TECHNICAL SPECIFICATIONS

On February 23, 1982, RG&E requested a change to the Technical Specification to permit storage of the higher enrichment OFA fuel in the spent fuel pool. In response to questions from the NRC staff concerning this submittal RG&E provided a criticality analysis of the new fuel storage racks on September 12, 1983.

Attached are three reports comprising the safety analysis prepared by Westinghouse covering the transition from an all Exxon fueled core to a full core of the OFA design. This safety analysis is not cycle specific, but uses parameters which will bound those experienced during the transition period. The safety analysis is composed of a summary of the mechanical, thermal-hydraulic and accident analysis and detailed results of the non-LOCA and LOCA analysis. These analyses incorporate the proposed changes to the Technical Specifications and show that the applicable design criteria for the Exxon and OFA are satisfied..

The proposed changes are required to allow the insertion of, and subsequent transition to, a full core of fuel assemblies of the Westinghouse Optimized Fuel Assembly Design (W-OFA). These changes have been incorporated into the assumpti

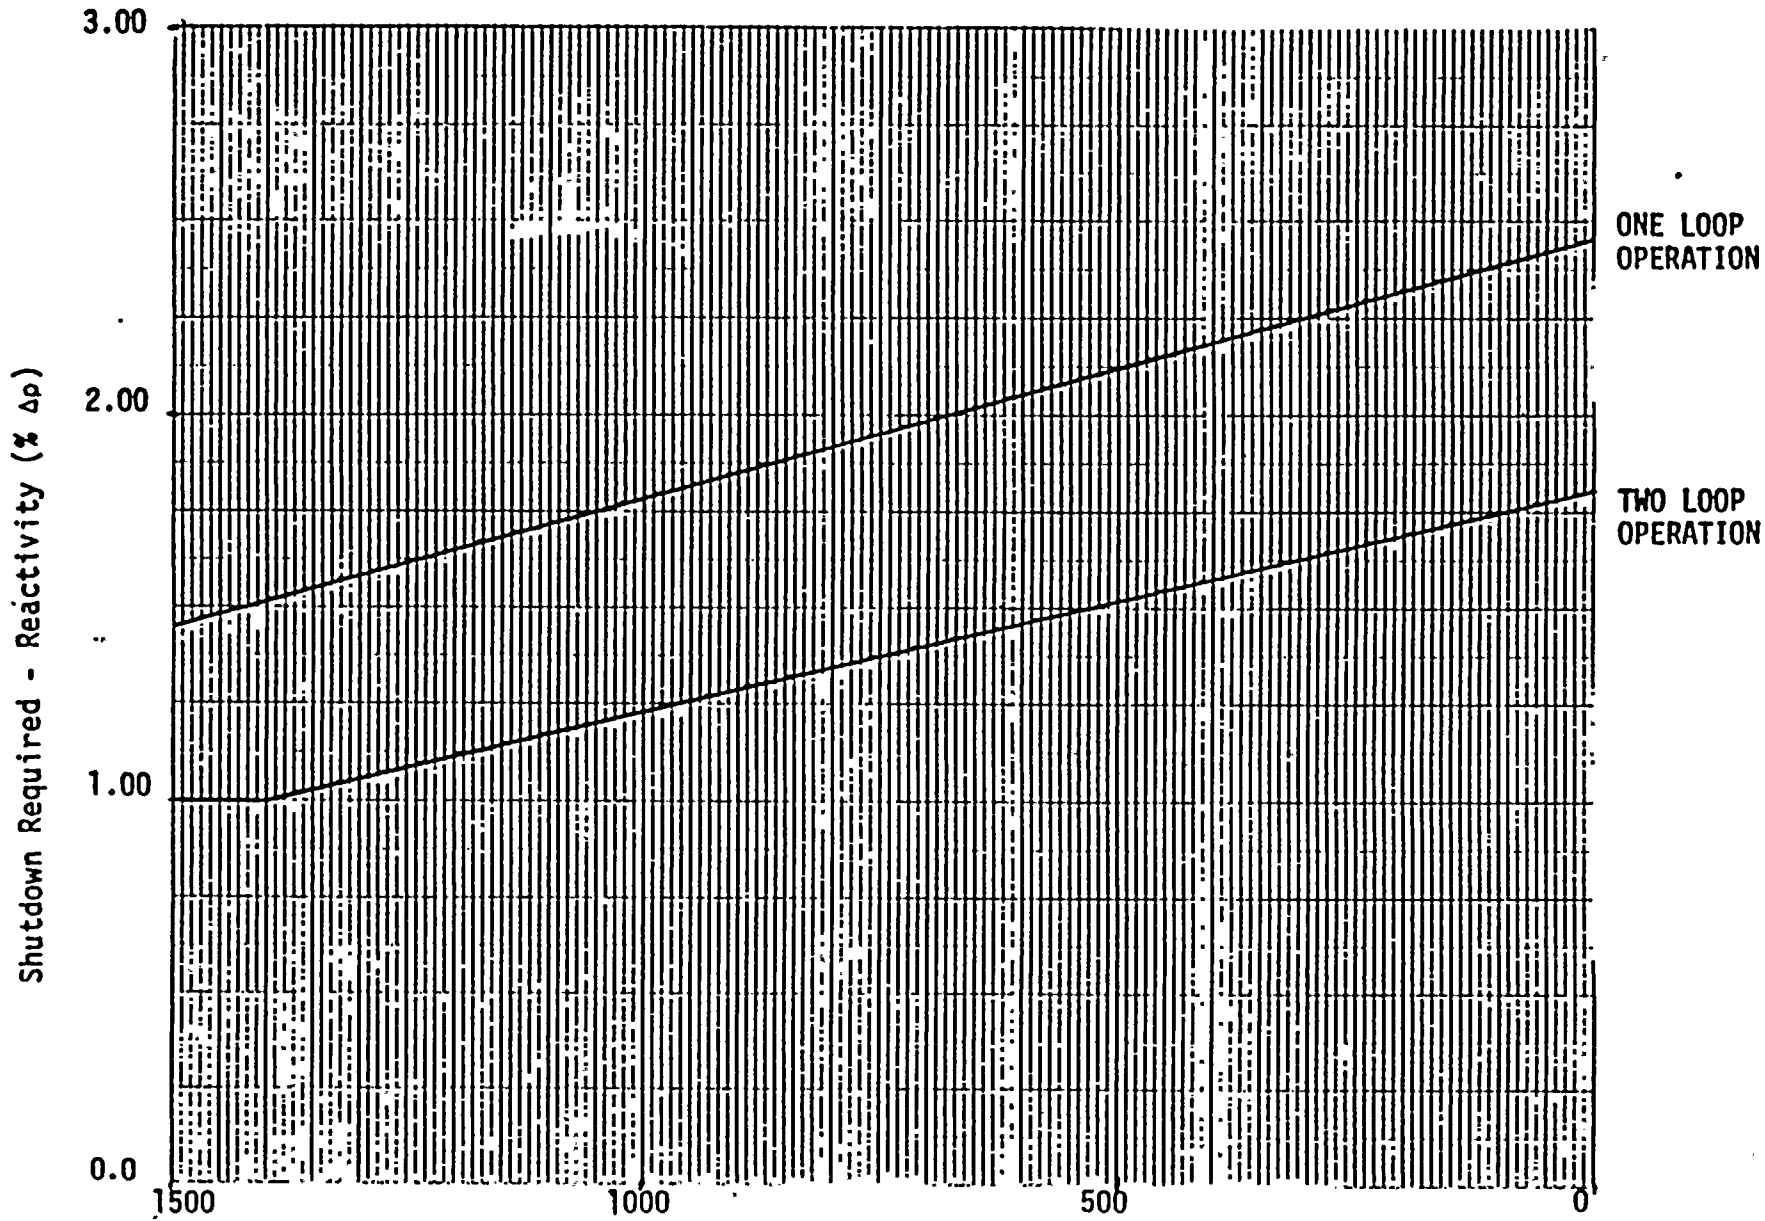
3.10.2.2 Power distribution limits are expressed as hot channel factors. At all times, except during low power physics tests the hot channel factors must meet the following limits:

$$\begin{aligned} F_Q(Z) &= (2.32/P)*K(Z) && \text{for } P \geq .5 \\ F_Q(Z) &= 4.64*K(Z) && \text{for } P \leq .5 \\ F_{\Delta H}^N &= 1.66 [1 + .3(1-P)] && \text{for } 0 \leq P \leq 1.00 \end{aligned}$$

where P is the fraction of rated power at which the core is operating, K(Z) is the function given by Figure 3.10-3, and Z is the height in the core. The measured F_Q^N shall be increased by three percent to yield F_Q . If the measured F_Q or $F_{\Delta H}^N$ exceeds the limiting value, with due allowance for measurement error, the maximum allowable reactor power level and the Nuclear Overpower Trip set point shall be reduced on percent for each percent which $F_{\Delta H}^N$ or F_Q exceeds the limiting value, whichever is more restrictive. If the hot channel factors cannot be reduced below the limiting values within one day, the Overpower ΔT trip setpoint and the Overtemperature ΔT trip setpoint shall be similarly reduced.
